DRAFT

Low Density Parity Check Coding

Figure x1 – FEC encoder

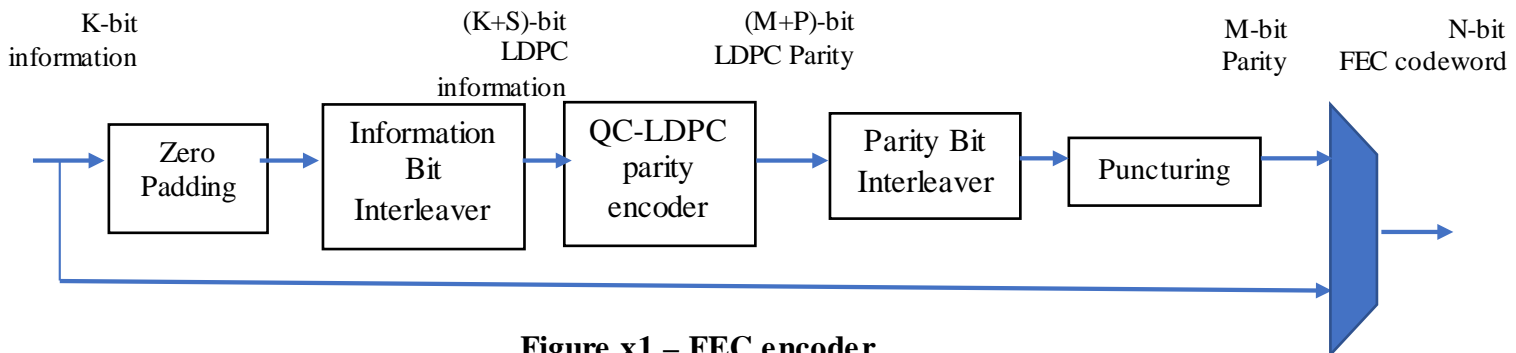
- the LDPC parity check matrix is a ~~123~~-by-~~6975~~ quasi-cyclic matrix, with circulant size $Z = 256$; LDPC user bit length before shortening is ~~5762~~ $\times 256 = 14,59215,872$, the parity bit length before puncturing is ~~123~~ $\times 256 = 3,072328$; the codeword length before any shortening and puncturing is ~~17,66419,200~~;

- the number of transmitted information bits, K (with maximum user length $K_{\max} = 14,3285,677$);
- the number of shortened information bits, S ($S_{\min} = 264195$);

- the number of punctured parity check bits, P ($P = 512$);
- the number of parity-check bits after puncturing, M ($M = 3,072328 - 512 = 2,560816$);
- the number of output bits, N ($N = K + M$, FEC codeword, whose size depends on the burst length pattern to determine shortening length); $N_{\max} = K_{\max} + M = 16,8888,493$;

The encoder supports highest code rate $R_{\max} = \frac{K_{\max}}{N_{\max}} = 0.848477$. Codes with lower code rates/shorter block length shall be obtained through shortening. The puncturing length and location are fixed for all scenarios.
